Access Compliance Report

Public Rights-of-Way

(Curb Ramps)

Intersection ID: 43309	Main Street: ALLENWOOD_RD	Cross Street: FALLS_LAKE_DR	Location:	N
ADA ID: F841B283DA2F	Ramp Type: Perp	Initial Pass/Fail: Fail	Overall Compliance: No	Severity Score: 10
Codes/Mitigation Info/Possible Solution		Field Measurements/Component Compliance

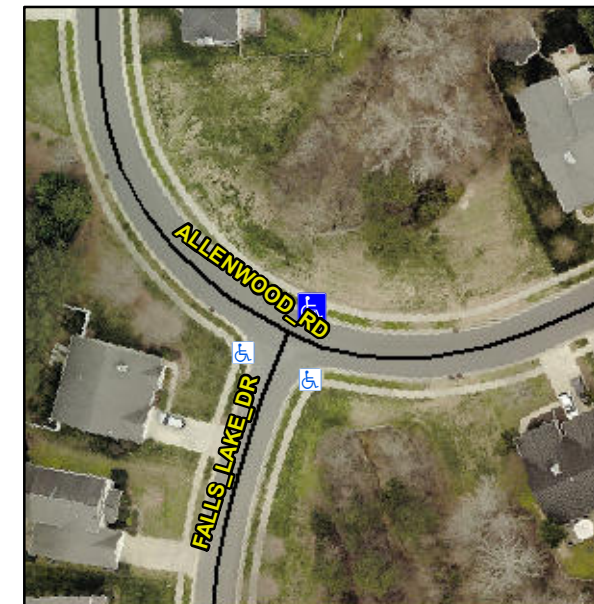
Not Found, R304.5.1

Compliance	Description	Data	Compliance	Description	Data
N/A	Ramp Length (in)	50.0	Yes	Ramp Slope (%)	5.0
No	Ramp Width (in)	46.5	Yes	Ramp XSlope (%)	2.6
N/A	Flare Type LT	N/A	N/A	Flare Type RT	N/A
N/A	Flare Slope LT (%)	N/A	N/A	Flare Slope RT (%)	N/A
N/A	Flare Traversable LT?	N/A	N/A	Flare Traversable RT?	N/A
N/A	Landing Length (in)	N/A	N/A	DWS Provided?	N/A
N/A	Landing Width (in)	N/A	N/A	DWS Contrast?	N/A
N/A	Landing Slope (%)	N/A	N/A	DWS Length (in)	N/A
N/A	Landing X Slope (%)	N/A	N/A	DWS Full Width?	N/A
N/A	Landing Curb? (Y/N)	N/A	N/A	DWS Offset (in)	N/A
N/A	Shared Landing?	N/A			
N/A	Gutter Ponding?	N/A	N/A	Gutter Slope (%)	N/A
N/A	Gutter Lip Ht (in)	N/A	N/A	Gutter X Slope (%)	N/A
N/A	Painted X Walk1?	No	N/A	Painted X Walk2?	N/A
	X Walk 1 Direction	To SW		X Walk 2 Direction	N/A
N/A	X Walk 1 Width (in)	N/A	N/A	X Walk 2 Width (in)	N/A
	X Walk 1 Slope (%)	2.1		X Walk 2 Slope (%)	N/A
	X Walk 1 X Slope (%)	3.2		X Walk 2 X Slope (%)	N/A

Remove & Replace Entire Ramp.
